PCR 007Puyallup
Corporate Center
E200137 June 12, 2022

PLAN CHANGE REQUEST

9. APPROVED CIVIL PLAN SHEET NUMBERS AFFECTED: C4, C12

Parking lot layout updated based on the revised site plan associated with the Red Dot TI work.

Job Number: 20705
Sheet: C4 of 23

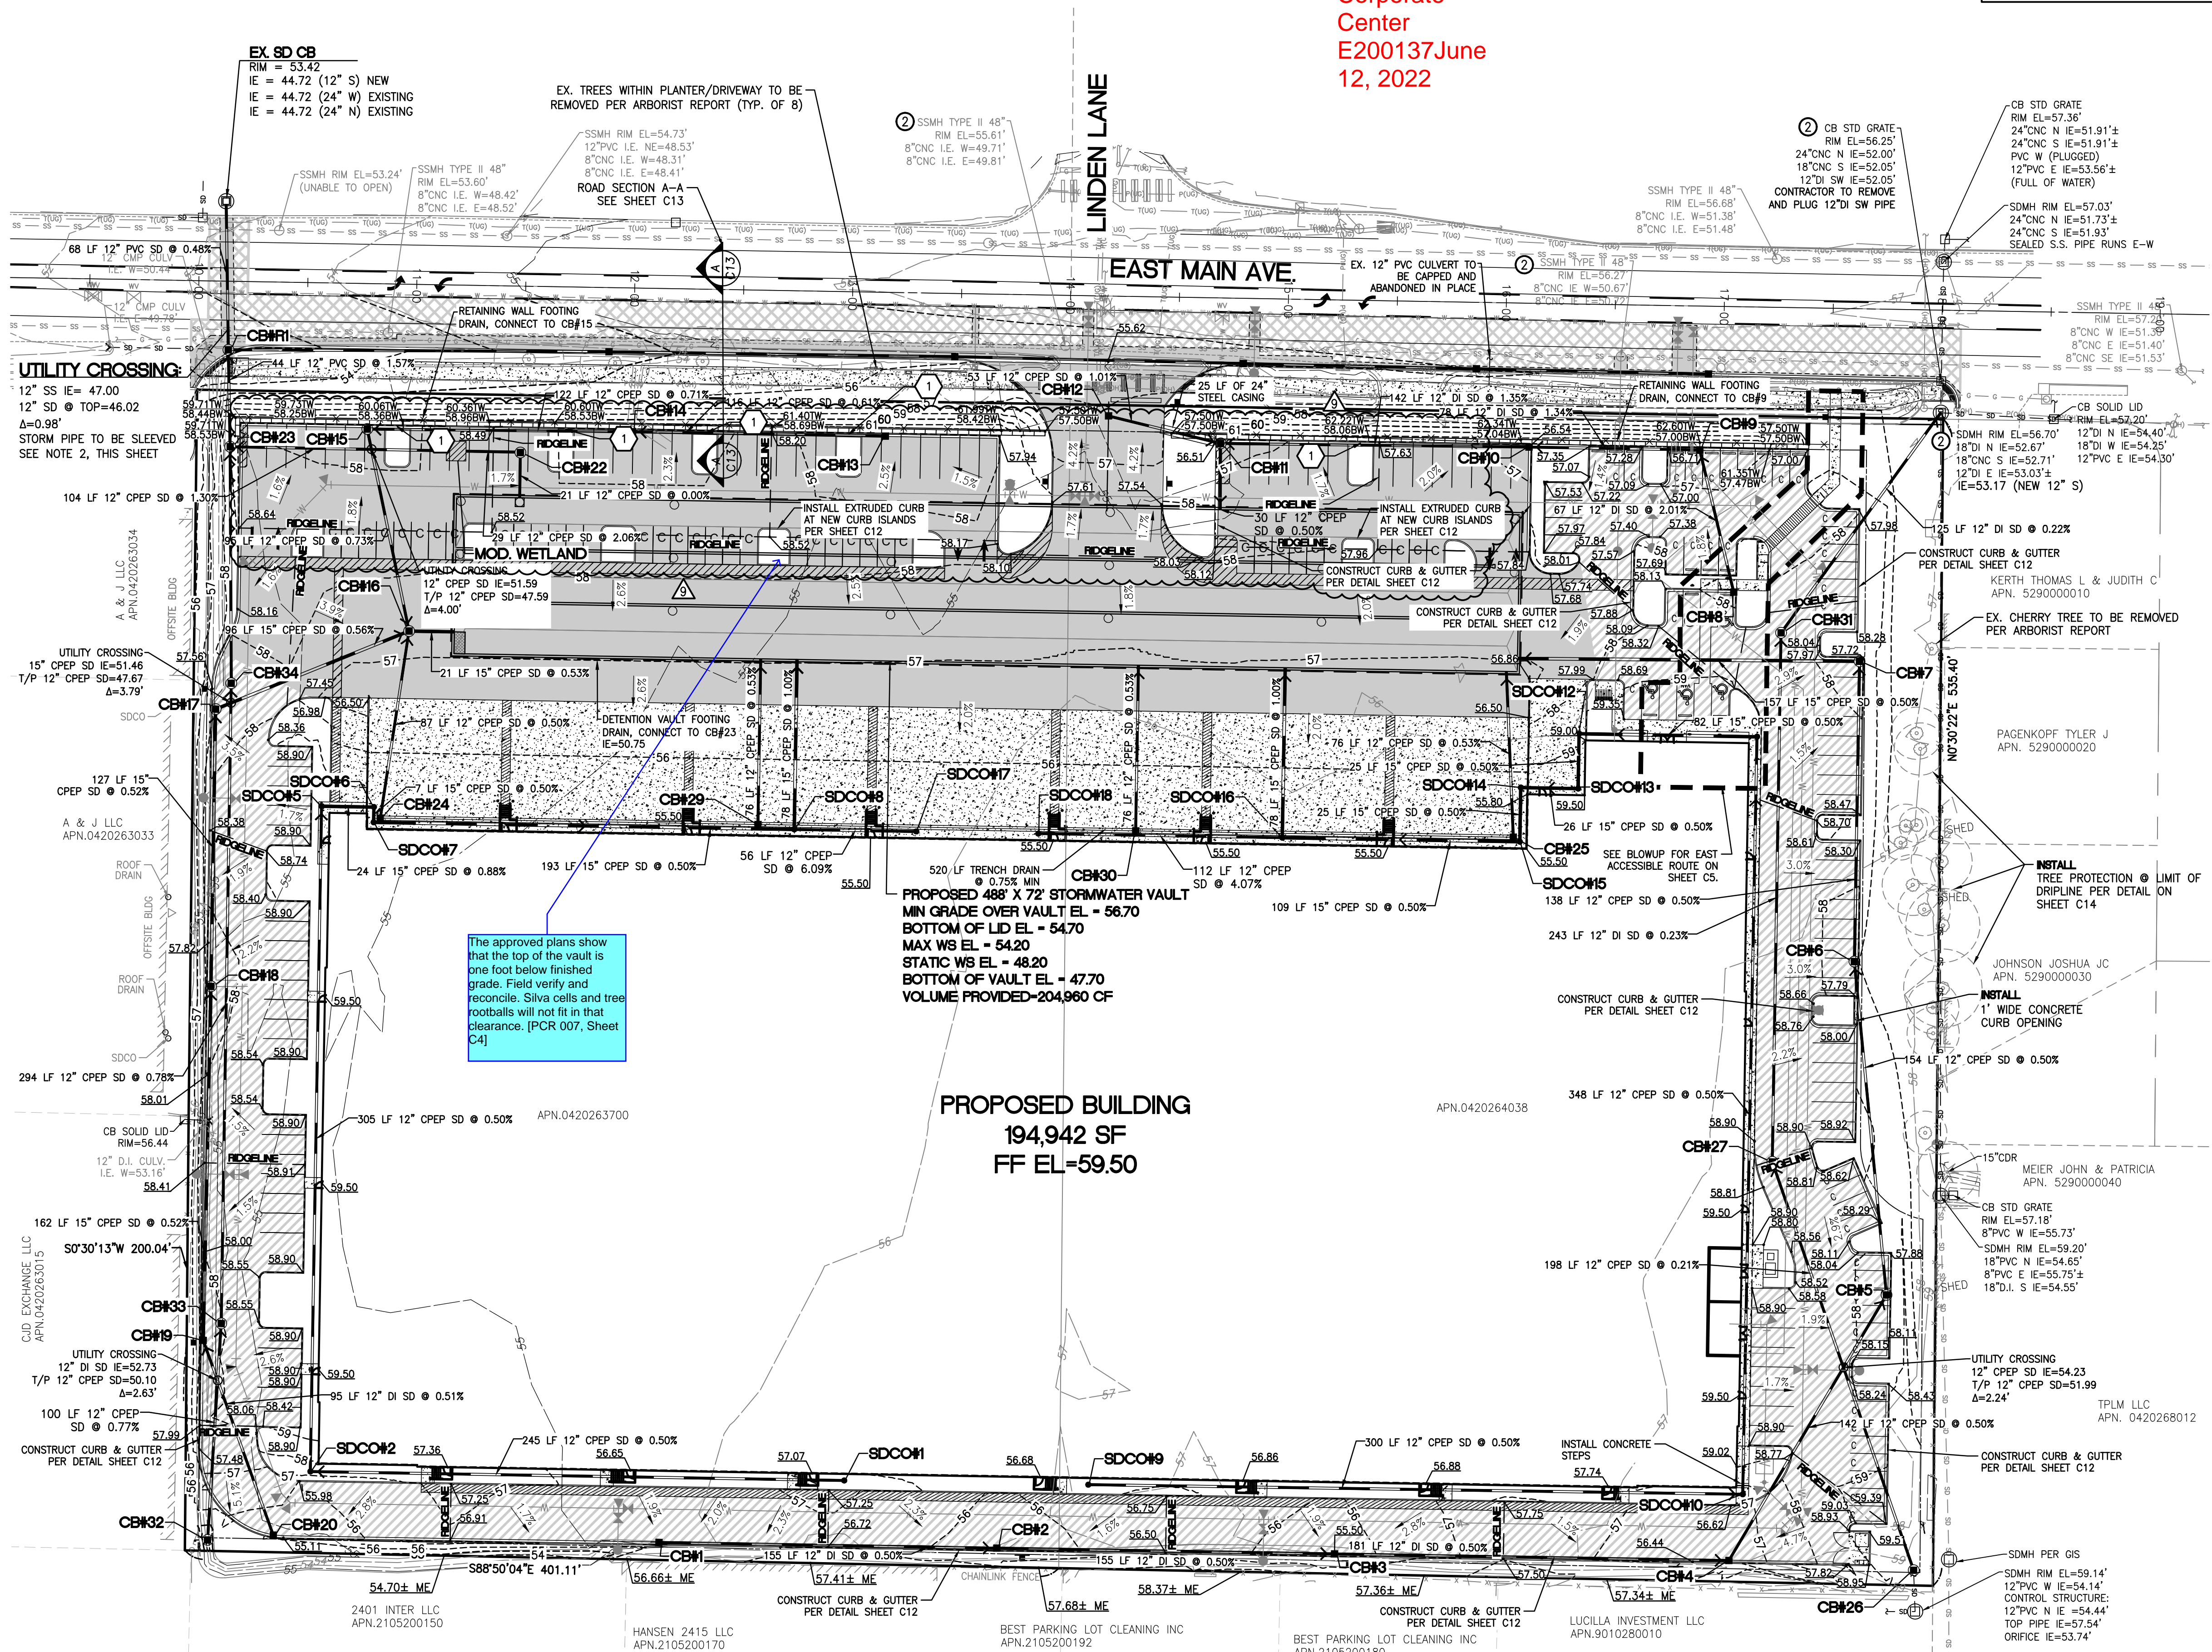
KEYNOTES
1. CONTRACTOR TO MAINTAIN A 1" CONCRETE GUTTER PAN ALONG NORTH SIDE OF NEW PLANTER ISLANDS
